# **Planning Commission Staff Report**

**SUBJECT:** DR20-71, GUADALUPE & MCQUEEN RETAIL

# FINDINGS OF FACT DR20-71, Guadalupe & McQueen Retail

**GUADALUPE AND MCQUEEN RETAIL - PAD A**

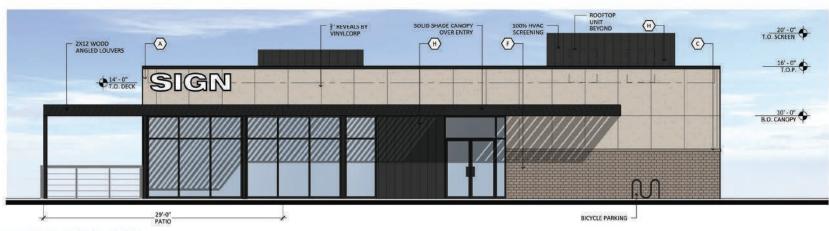
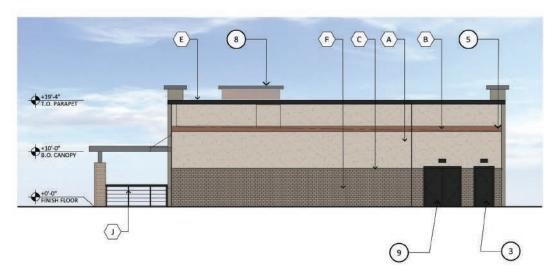
The only first review comment on Pad A was the suggestion to bring the windows down to the base of building to provide balance on the south elevation. Pad B for the four retail and restaurant suites is of a similar design with a different massing of the colors and materials to differentiate the four separate suites. For Pad C, the automotive building, staff has recommended that the canopies be raised on the west and north elevations to create more balance, and to provide variation in the columns in between the bays. This has been requested in the past in auto-oriented businesses with bays to provide some movement to such a large elevation. The materials are a combination of stucco, EIFS, and accents of splitface and smooth CMU block and metal. Photos were provided of the surrounding developments showing a desert palette and similar architecture.

# GUADALUPE AND MCQUEEN RETAIL - PAD C

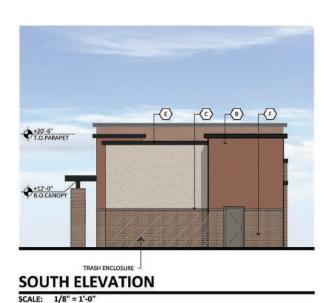
- The Commission was generally supportive of the project and was complimentary of the proposed uses, elevations, and site layout.
- For Pad C, it was recommended to provide a variation in the columns and to raise the
  elevation at the corner piece at the entry and increase the height of the parapet to
  accent the entry point of the building.
  - The applicant raised the canopy located at the entrance and provided a variation in height and width of the columns on both the west and east elevations.
